Serial No. 04-347  
ESP/JDH  
Docket No. 52-008

**DOMINION NUCLEAR NORTH ANNA, LLC**  
**NORTH ANNA EARLY SITE PERMIT APPLICATION**  
**RESPONSE TO REQUEST FOR ADDITIONAL INFORMATION NO. 5**

**Enclosure 1**  
**Response to NRC RAI Letter No. 5**

Figure 1. Geologic map of the Mountain Run Fault Zone (taken from Mixon et al., 2000). Profiles constructed across the fault, and illustrated in Figures 3-11, are indicated by black lines labeled A-I.

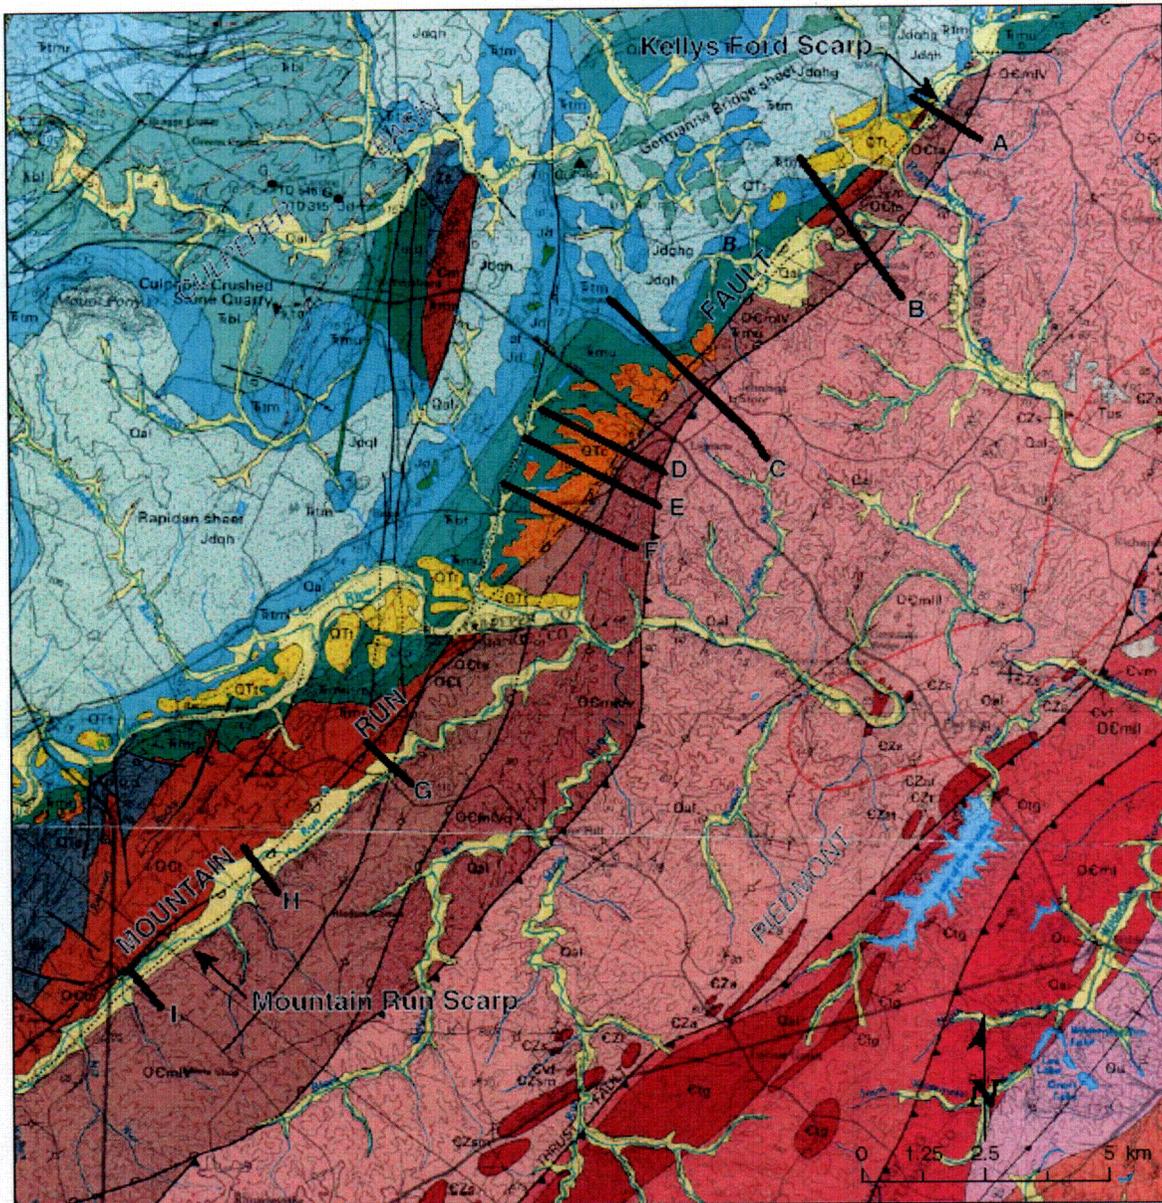
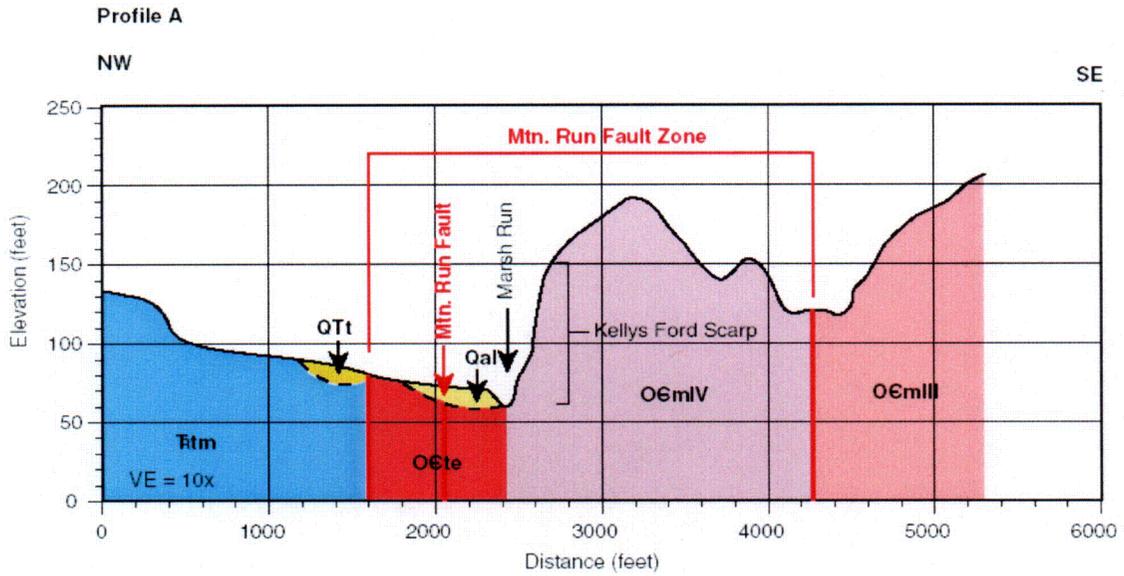
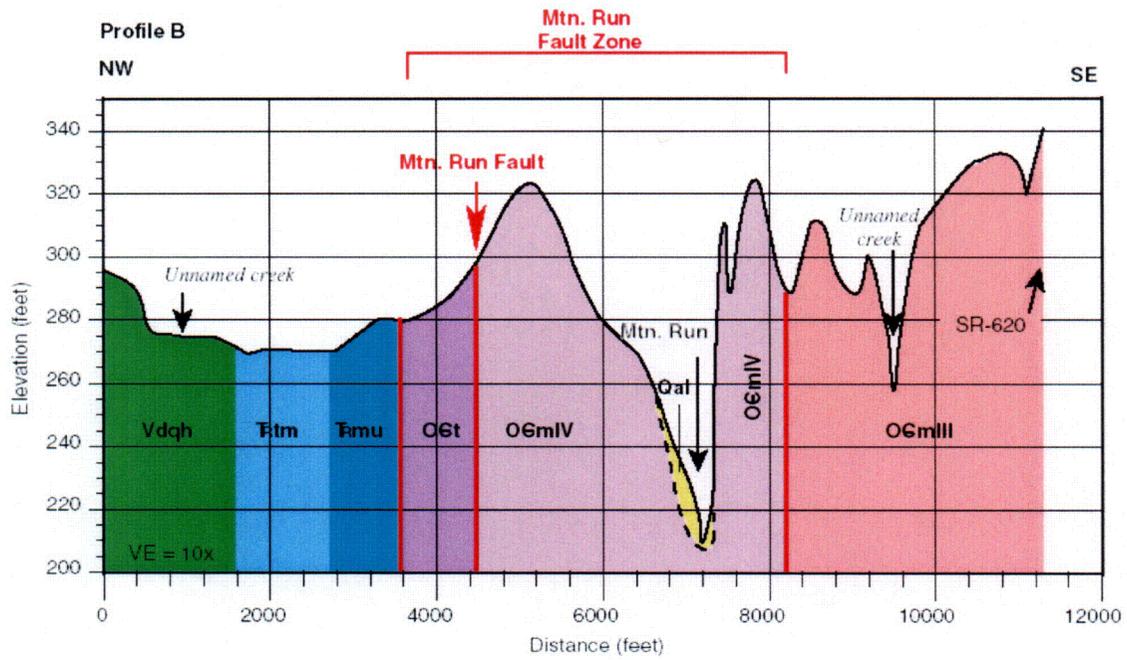
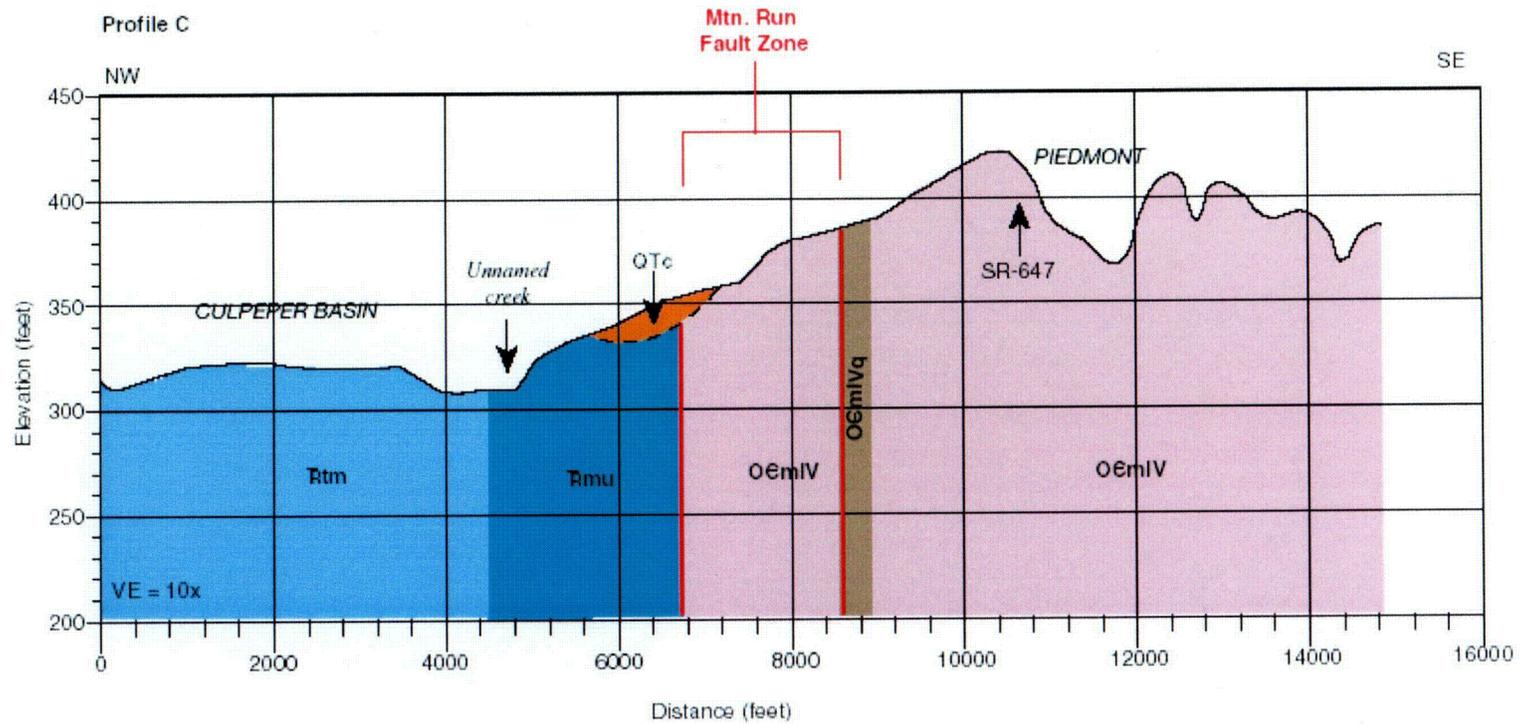
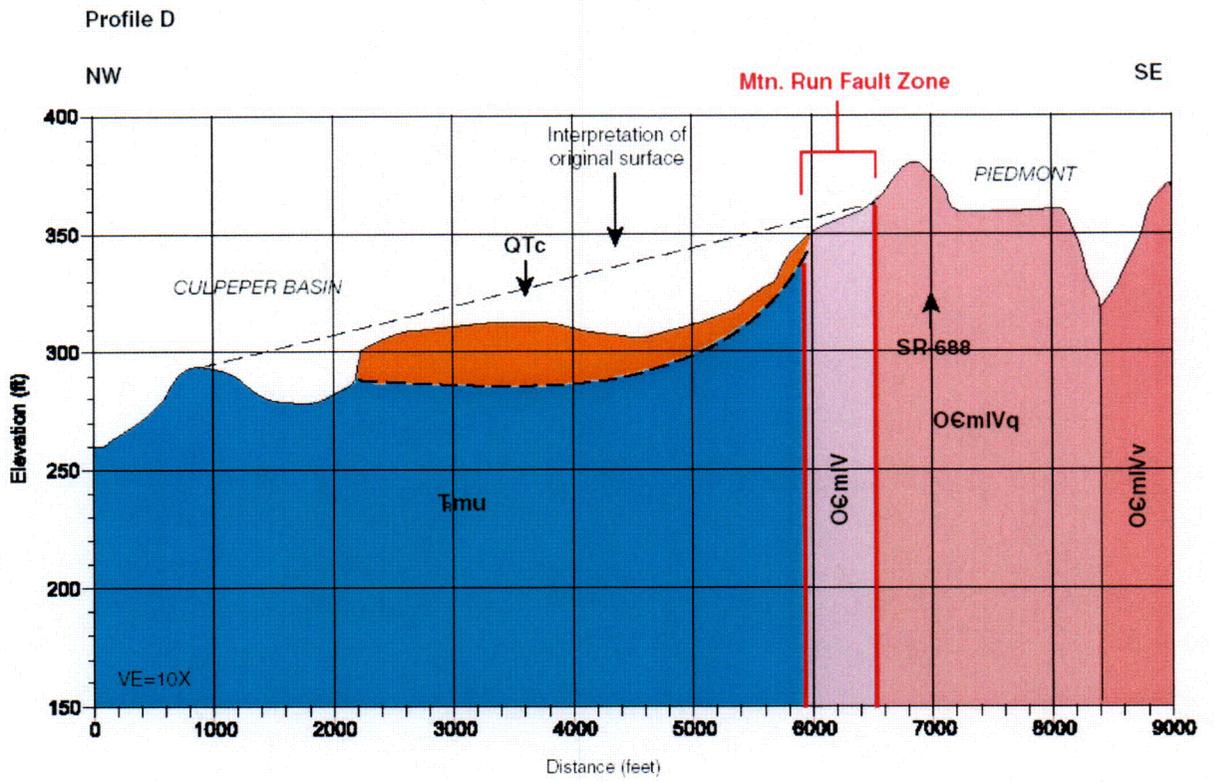
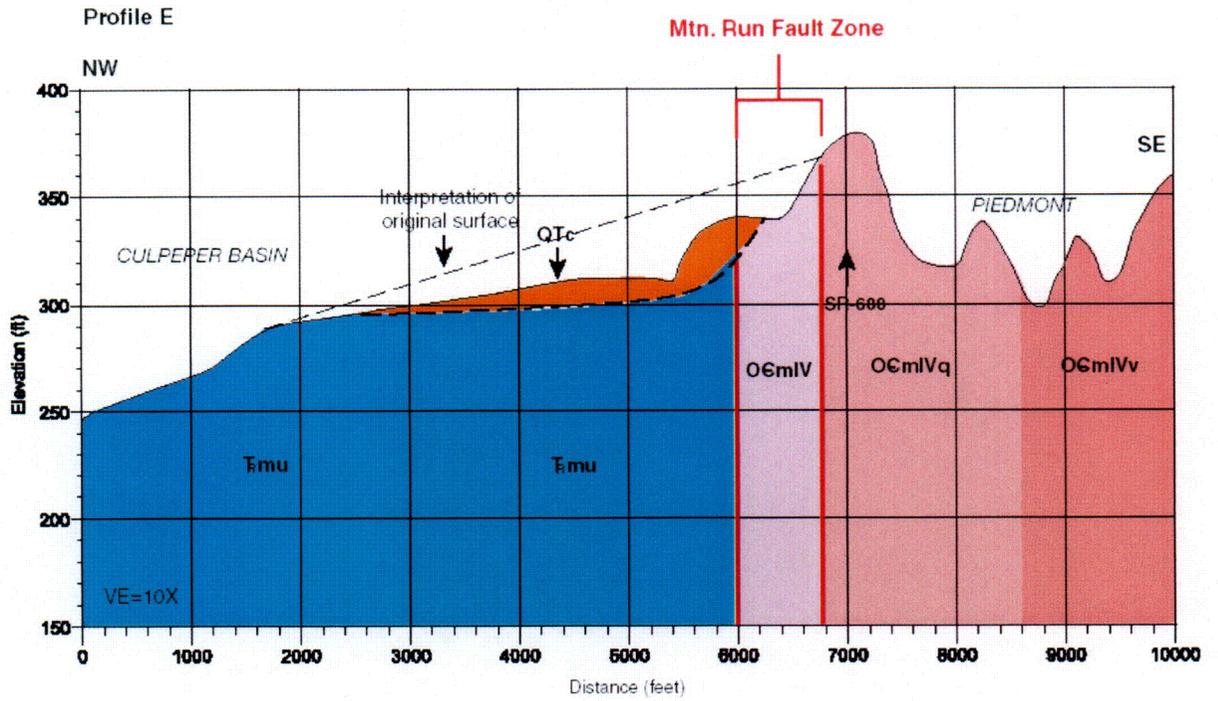
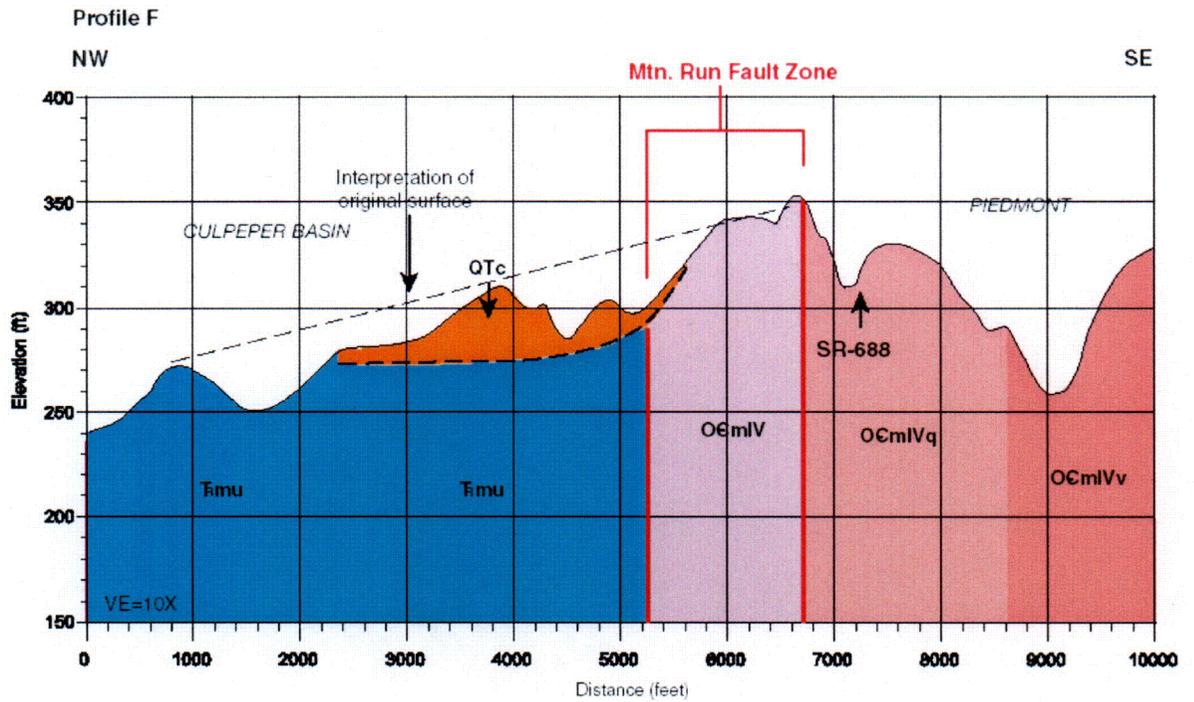
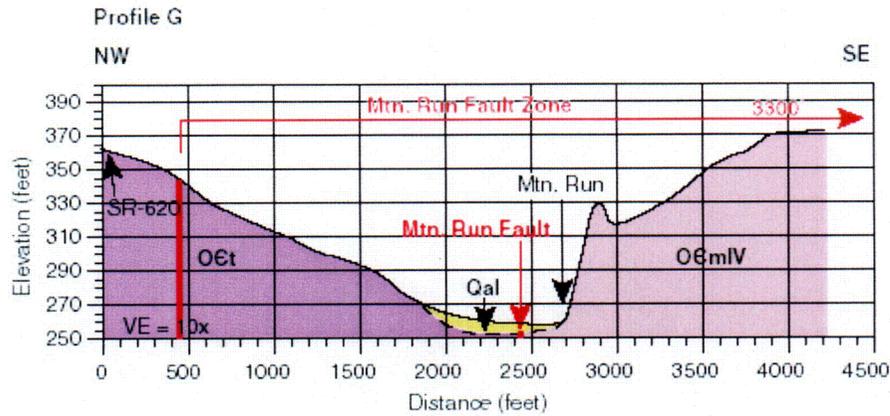
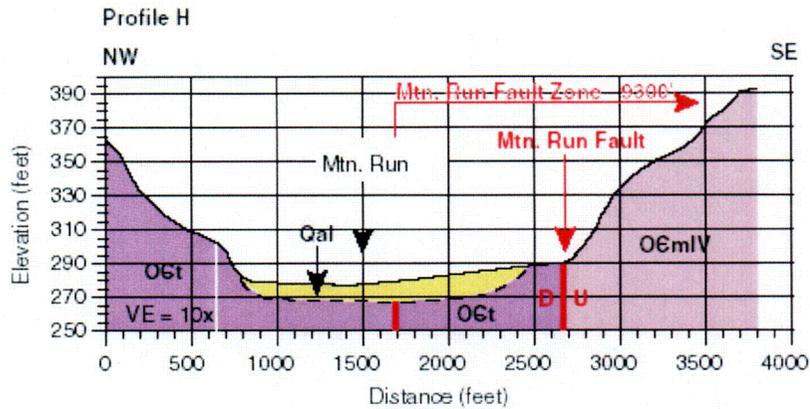
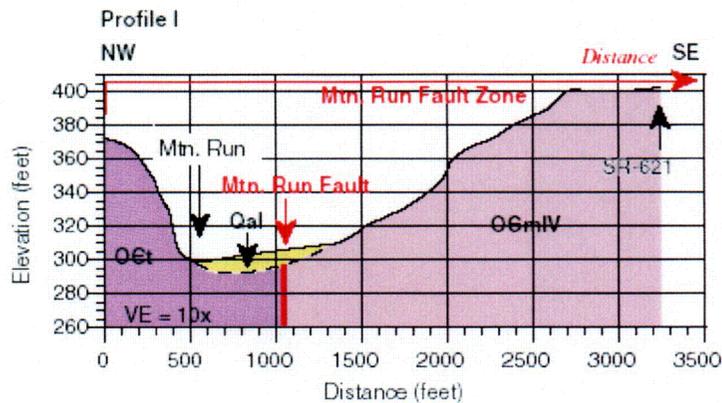
SSAR Subsection 2.5.1.1.4 describes the Mountain Run and Kelly's Ford scarps along the Mountain Run fault zone and states that field and aerial reconnaissance did not reveal any geologic or geomorphic features indicative of potential Quaternary activity along the Mountain Run fault zone. Please describe the relevant physiographic features associated with these two scarps and the evidence that led to the conclusion that "the scarp most likely formed due to erosion, as southeastward-migrating streams impinge against more resistant rocks of the Mountain Run fault zone."

The northern two profiles (profiles A and B on Figure 1) cross the Mountain Run fault zone north and south, respectively, of the point where the east-flowing Rappahannock River exits the Culpeper Basin. Profile A (Figure 3) crosses the Kelly's Ford scarp, which is a prominent northwest-facing scarp in Paleozoic bedrock on the southeast side of the Marsh Run drainage, just northeast of its confluence with the Rappahannock River. Profile B (Figure 4) crosses the Mountain Run fault zone and Mountain Run creek southwest of the Rappahannock River. Both profiles document northwest-facing slope breaks on the southeast sides of the valleys that contain Marsh Run and Mountain Run; however, there is no consistent association of these slope breaks with faults within the Mountain Run fault zone. Whereas the Kelly's Ford scarp is adjacent to the buried trace of the Mountain Run fault (Figure 3), the pronounced bedrock scarp on the southeastern margin of Mountain Run valley is located about 3000 ft southeast of the mapped trace of the Mountain Run fault (Figure 4). If the Kelly's Ford scarp in Profile A formed by repeated late Cenozoic west-side-down surface rupture on the Mountain Run fault, then we would reasonably expect to see a similar scarp or geomorphic expression of movement along the fault approximately two miles on strike to the south at Profile B. Instead of being consistently associated with the fault, however, the northwest-facing scarps in both profiles are associated with incised drainages that are preferentially eroding the southeast valley walls, creating asymmetric valley profiles. We interpret that the Kelly's Ford scarp and northwest-facing scarp that forms the eastern valley wall of Mountain Run are products of fluvial erosion, not late Cenozoic fault activity.

The central group of four profiles (profiles C, D, E and F on Figures 5-8, respectively) all cross the Mountain Run fault zone where it is buried by late Neogene colluvial deposits (i.e., "QTc" on Figure 1) that mantle a broad, 5000-ft- to 6000-ft-long northwest facing slope, which drops gently from the Piedmont province into the eastern Culpeper Basin between Mountain Run creek and the Rapidan River (Figure 1). The Mountain Run fault zone generally is mapped by Mixon et al. (2000) in the central to eastern part of this slope. The fault zone is not located at the base of the slope and thus the slope

Profiles D through F reveal that the broad, northwest-facing slope between the Piedmont province and Culpeper Basin is interrupted by short reaches with steeper gradients. Inspection of the Germanna Bridge 7.5-minute topographic map indicates that the steeper slope reaches are associated with ephemeral streams that are incised into, and dissect, the originally smooth slope. For example, the gradient of the NW-facing slope in Profile D increases abruptly west of the Mountain Run fault zone (approximately at horizontal distance 5900 ft; Figure 6). The increased gradient is directly associated with the valley of an ephemeral stream that is incised in the broad slope, and which is obliquely intersected by the profile. In Figure 6 we show an interpreted reconstruction of the northwest-facing slope as a smooth surface prior to incision, and the incised valley can be seen as an asymmetric convexity in the topographic profile below the reconstructed smooth surface. Another incised stream valley impinges on Profile D at horizontal distance 1800 ft. Here, the profile of the incised valley is more symmetric because the stream and valley intersect the profile at a higher angle.

Similarly, two short, relatively steep reaches of slope occur at horizontal distances of 5600 ft and 6600 ft on Profile E (Figure 7). Although one of the steep reaches is located within the Mountain Run fault zone, neither reach is associated with a mapped fault trace (Figure 7). Examination of the adjacent topography on the Germanna Bridge 7.5-minute quadrangle map shows that both steep reaches of the slope are associated with the headwaters of incised, ephemeral drainages that obliquely intersect Profile E. As in Profile D, we show an interpreted reconstruction of the NW-facing slope prior to incision of these drainages as a smooth surface (Figure 7). Fluvial dissection of the slope is more obvious on Profile F (Figure 8), where ephemeral streams cross the profile at higher angles and have incised obvious convex valleys below the originally smooth, contiguous slope surface.

The southern three profiles G, H, and I (Figures 9-11) cross the Mountain Run valley southwest of the Rapidan River (Figure 1). The profiles clearly document that fluvial incision, rather than tectonic movement, has created relatively steep bedrock escarpments along the margins of Mountain Run valley. At Profile G (Figure 1),

Mountain Run valley is distinctly asymmetric with a steeper southeastern valley wall (Figure 9). The stream presently hugs the southeastern valley wall, and the valley geometry indicates that Mountain Run has preferentially undercut the southeastern margin of the valley during late Cenozoic incision. In contrast, Profile H (Figure 10), which is located about two miles southwest of Profile G (Figure 1), reveals a more symmetric valley. Here, Mountain Run flows through the center of the valley, and there are modest bedrock escarpments along both sides of the valley. Moving southwest from Profile H, the valley profile becomes asymmetric again, with Mountain Run flowing adjacent to the steeper northwestern valley wall (Profile I, Figure 11). The asymmetry of Mountain Run valley in Profile I indicates that the stream preferentially undercut the northwestern valley wall during incision. We conclude that the reversal in valley asymmetry and creation of both northwest- and southeast-facing bedrock scarps along the valley margins is due to fluvial erosion. This reversal in valley asymmetry is not consistent with late Cenozoic, northwest-side-down displacement along the Mountain Run fault zone.

Figure 1. Logic tree for sources used to represent Charleston area earthquakes.

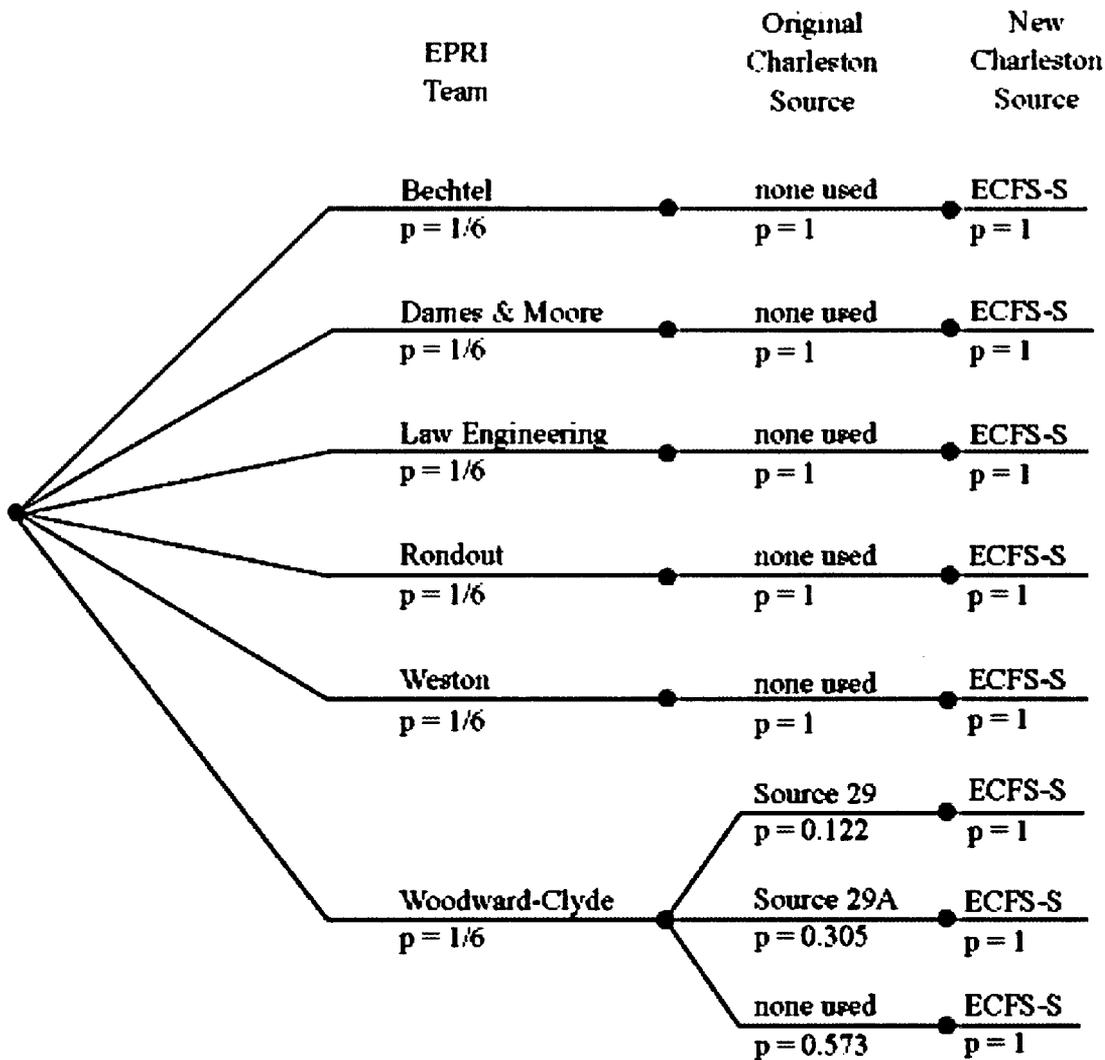
- b) Please provide a logic tree, similar to SSAR Figure 2.5-35, that covers all of the source models for the Charleston seismic source, including the weights for maximum magnitudes and recurrence intervals as well as the probabilities of activity for each of the models.

Figure 1 shows a logic tree illustrating how the Charleston seismic source was modeled for seismic hazard sensitivity calculations.

For the sixth EPRI Earth Science Team (Woodward-Clyde Consultants, WCC), two alternative original representations of the Charleston source did contribute significantly to the seismic hazard at North Anna, as reported in SSAR Table 2.5-10. Therefore WCC sources 29 and 29A were included in the seismic hazard sensitivity calculations for North Anna. Weights for maximum magnitudes  $m_{\max}$  (on the  $m_b$  scale), recurrence intervals, and probabilities of activity for these two sources are shown in the Table 1. For this table, the recurrence interval of each  $m_{\max}$  value was calculated assuming that the largest value of  $m_{\max}$  applied.

For the Woodward-Clyde team, in addition to these sources 29 and 29A, the ECFS-S fault was added to the WCC source model to represent the hazard of a large-magnitude earthquake in the Charleston area with a recurrence interval of 550 years. The magnitudes, weights, and recurrence interval used for the ECFS-S fault are shown in SSAR Figure 2.5-35.
